**BEFORE THE MIAMI BEACH CITY COMMISSION  
DESIGN REVIEW BOARD FILE 16-0082  
2120 LUCERNE AVENUE**

**PETITION TO REVERSE DESIGN REVIEW BOARD DECISION**

**DESIGN REVIEW BOARD**  
**City of Miami Beach, Florida**

FILE NO: DRB16-0082

## TREE PLAN

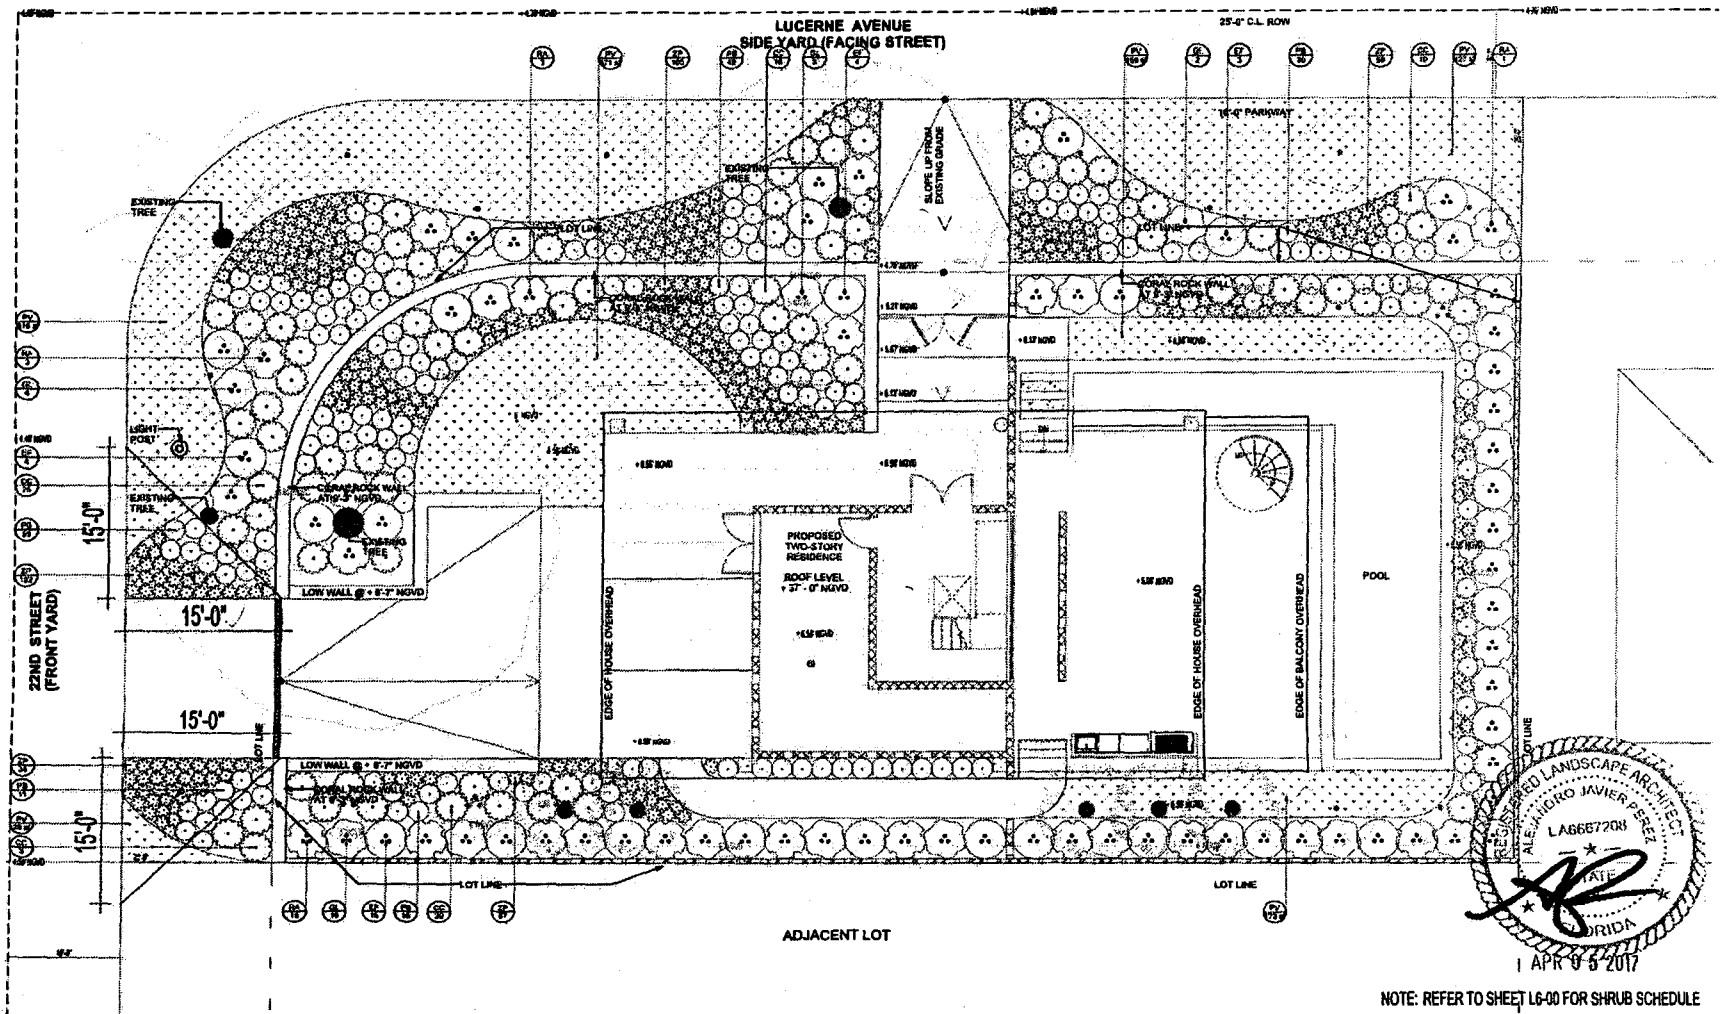
- c. In order to protect the root system of existing trees #5 and 6, as identified on sheet L1-20, the architect shall remove the section of the coral rock wall proposed at the property line, and low walls outlining the driveway/parking edge located within the dripline of the trees. A less intrusive fence, such as picket / wire mesh shall be provided in these sections in order to secure the property. Also, the hardscape area in the public ROW and within the dripline of tree #6 shall be removed. A 3' wide walkway may be provided for pedestrian access subject to the review and approval of the Public Works Department and CMB Urban Forester.

In addition, the landscape design calls to retain canopy trees and palms. Staff has concerns with the proposed hardscape and low walls that are near existing trees #5 and #6 and recommends that the landscape architect revise the proposed design so that proposed elements do not compromise the existing root systems of the trees. Lastly, the proposed landscape buffer within the west interior side yard should be further enhanced in order to provide a continuous landscape buffer. Staff recommends additional tall plantings, 25' minimum in height at the time of installation. Further, the finish material of the walkway should consist of ornamental landscape gravel in order to enhance rooting space for trees/palms and/or bamboo specified to provide screening.
